**CITY OF ISLE OF PALMS, SOUTH CAROLINA
REQUEST FOR BIDS (RFB) 2025.04
WILD DUNES GOLF COURSE- FLOOD MITIGATION IMPROVEMENTS
Response to Questions August 19, 2025**

HP STORM INSTALLATION GUIDE

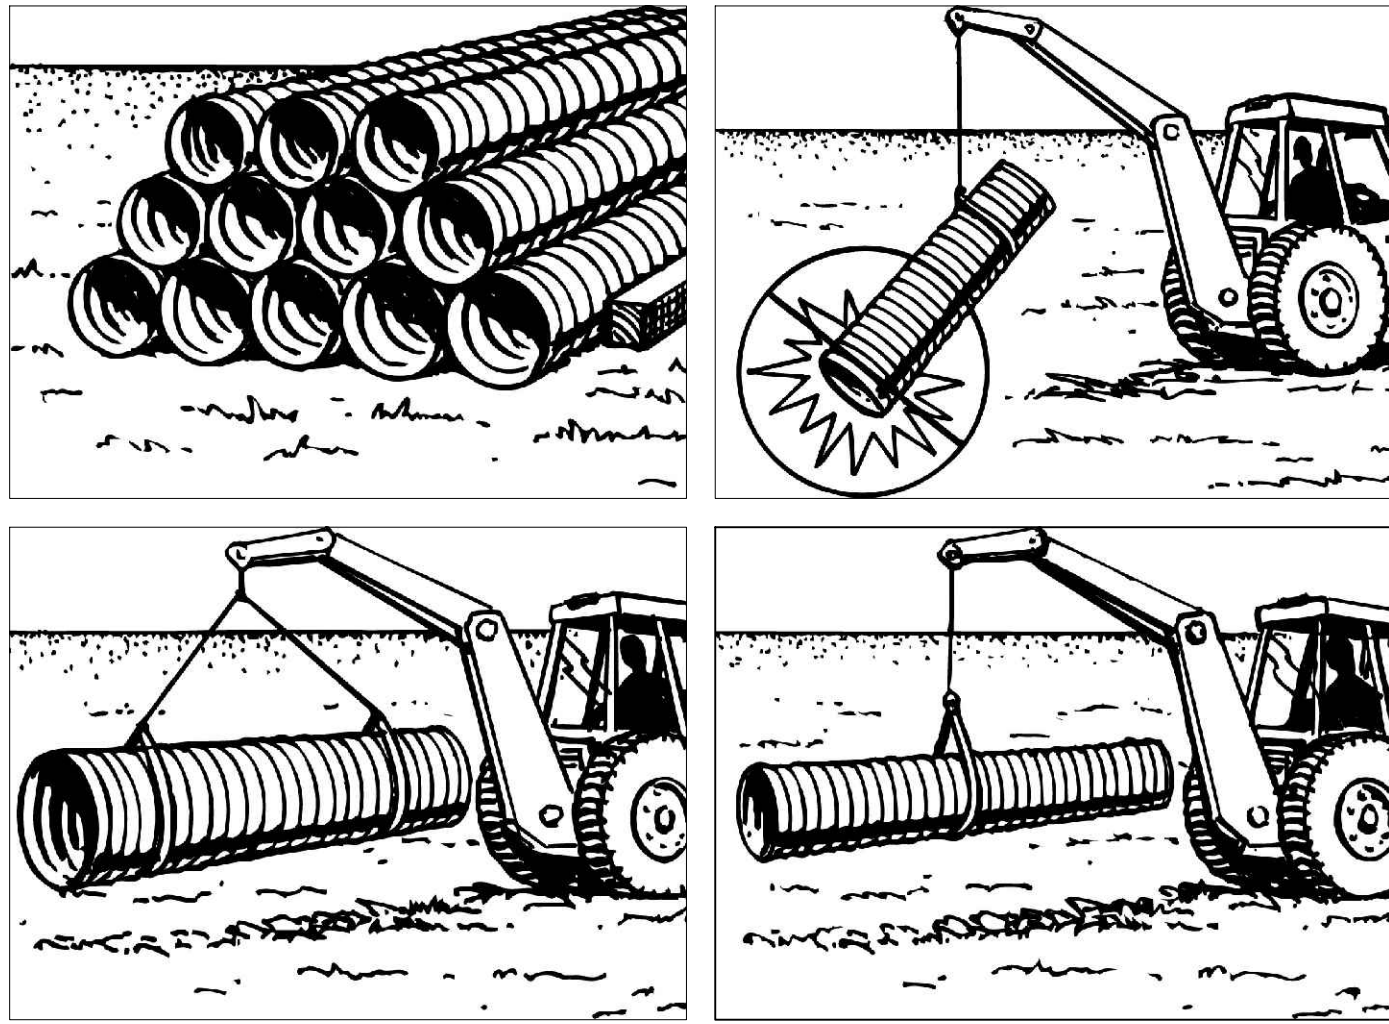
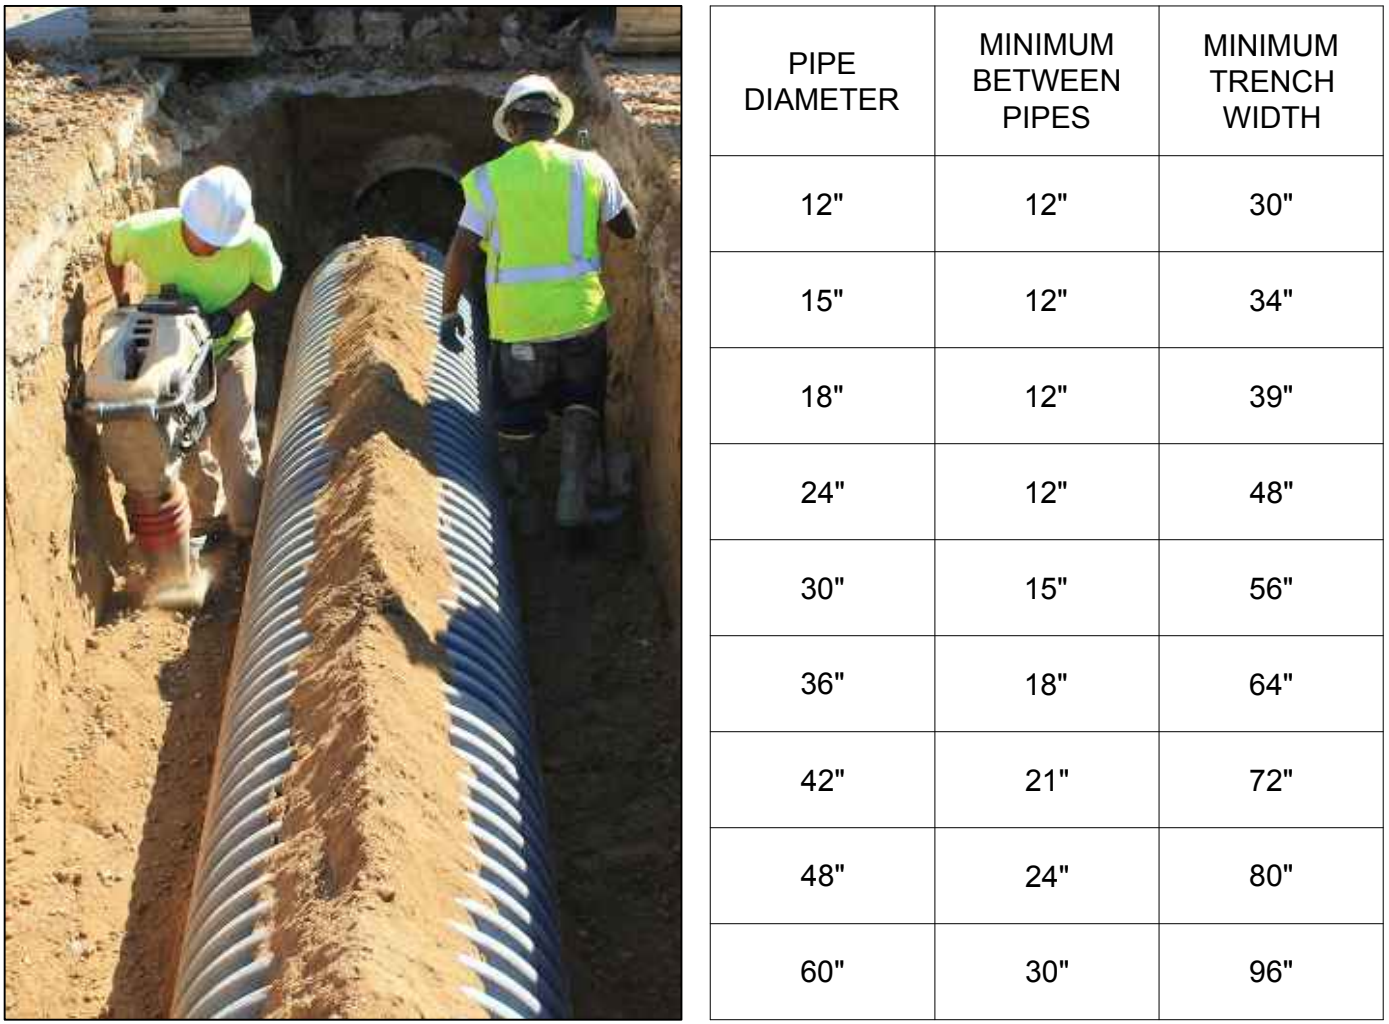
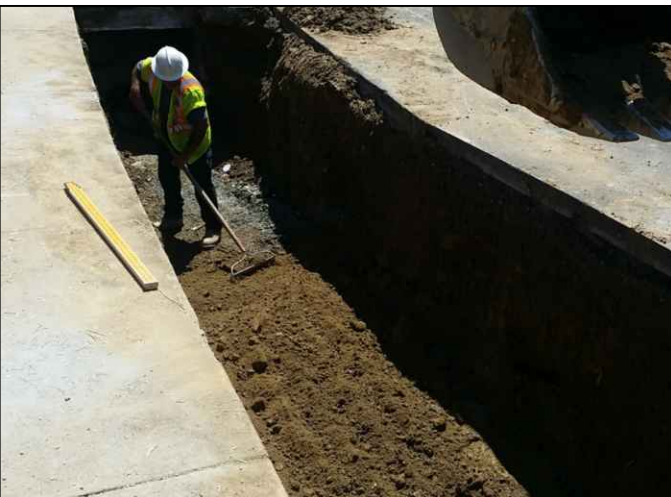
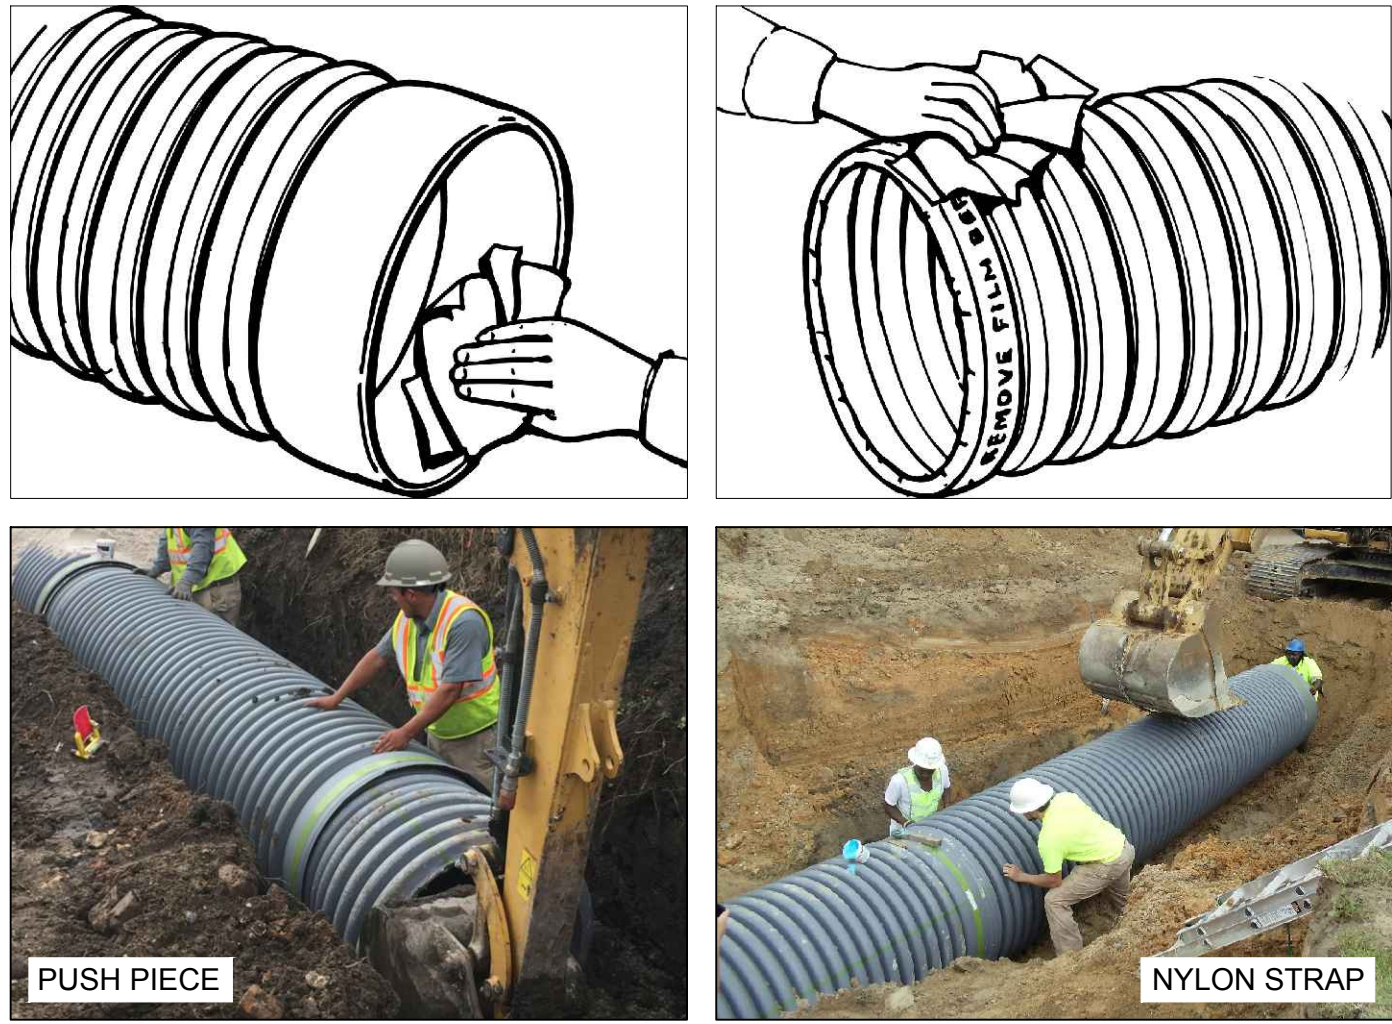
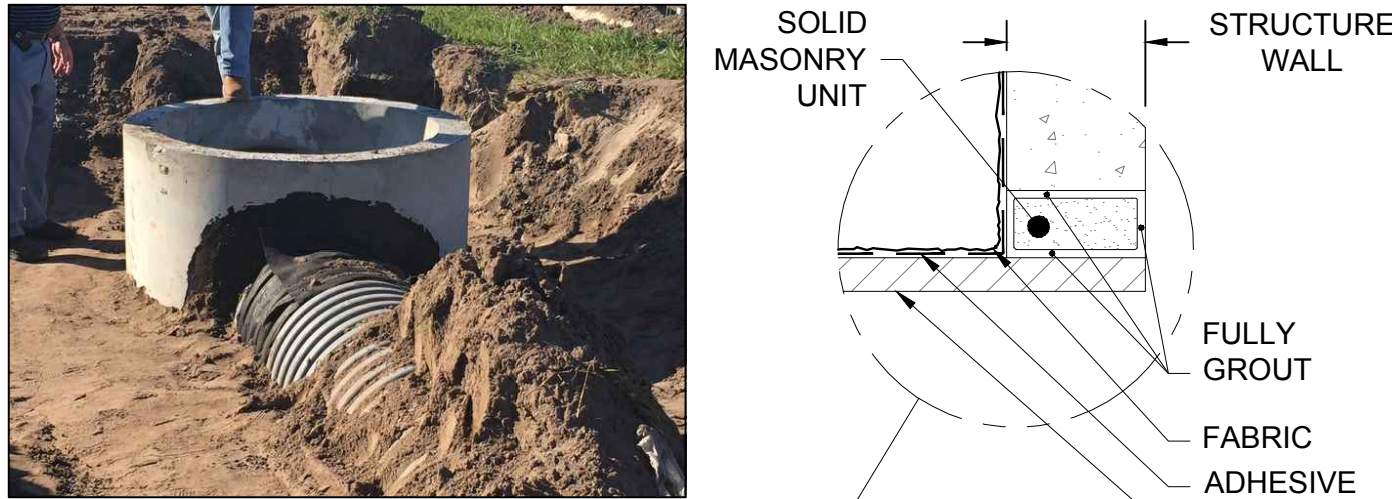
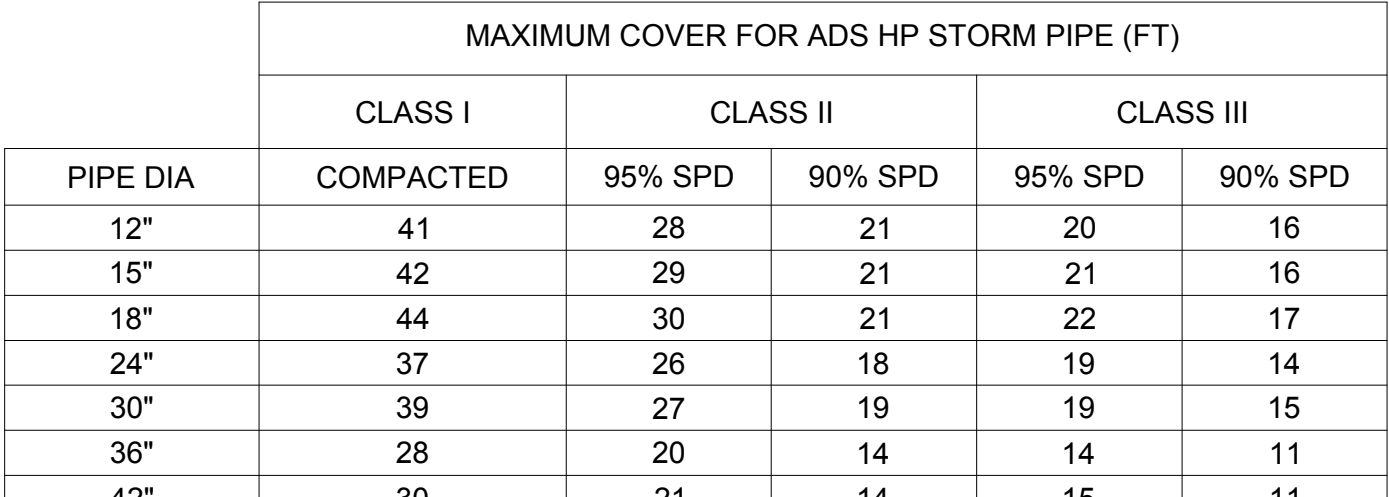
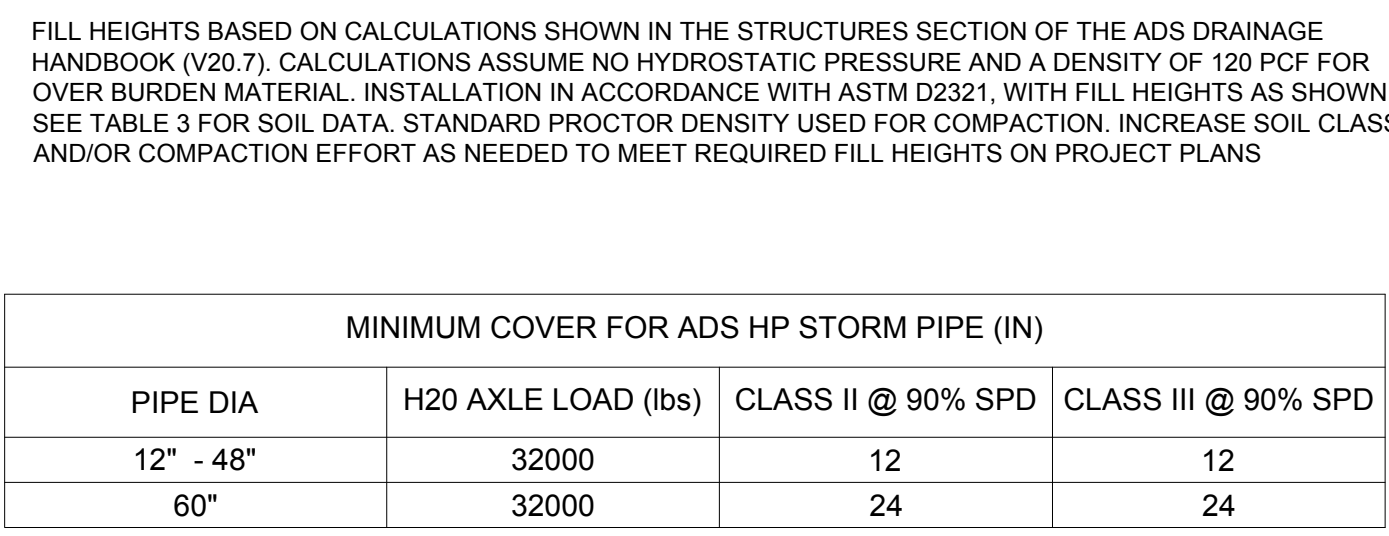
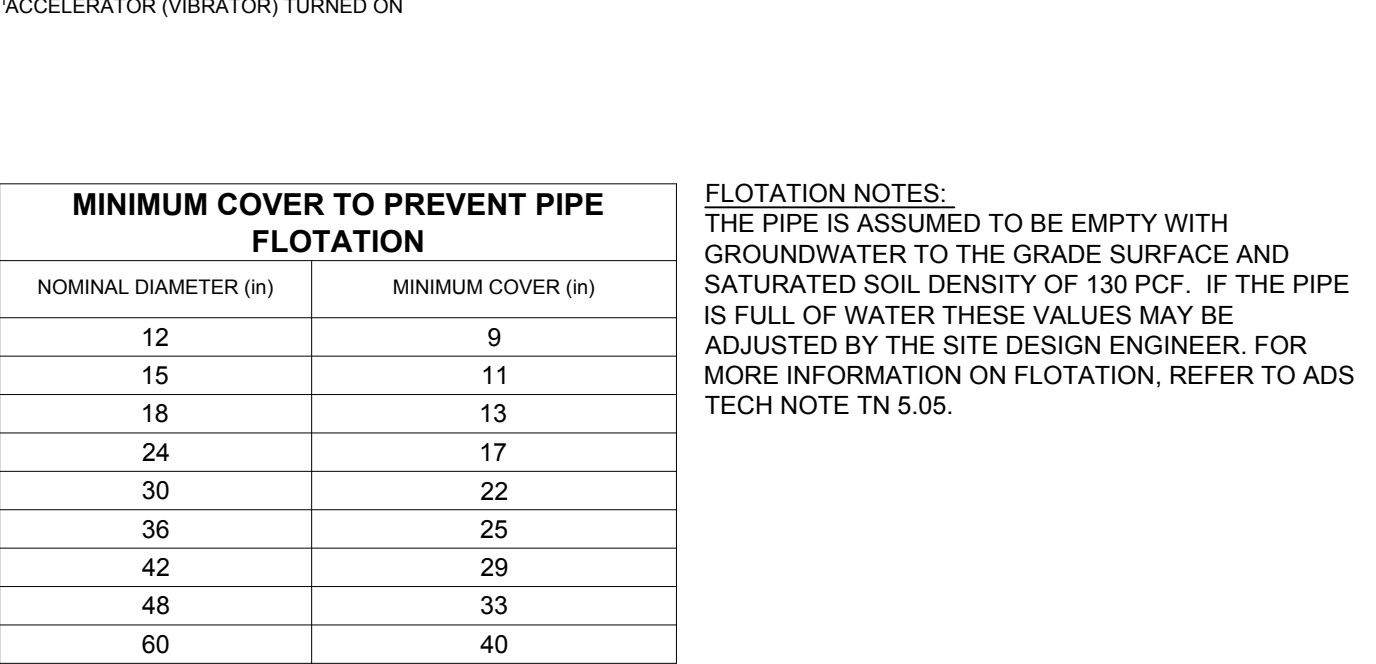
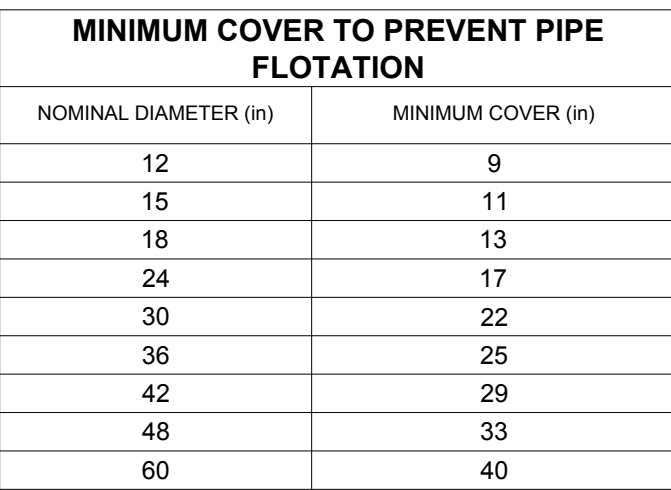
16. Should any bedding material be anticipated for HDPE pipe?

Response: all HDPE pipe shall be installed per the manufacturer's recommendations. Attached are the recommendations for ADS branded pipe. If the contractor uses ADS – they should follow these recommendations. The contractor can propose alternate brands, but should provide installation recommendations and the alternate must be verified for meeting the needs of the project prior to installation.
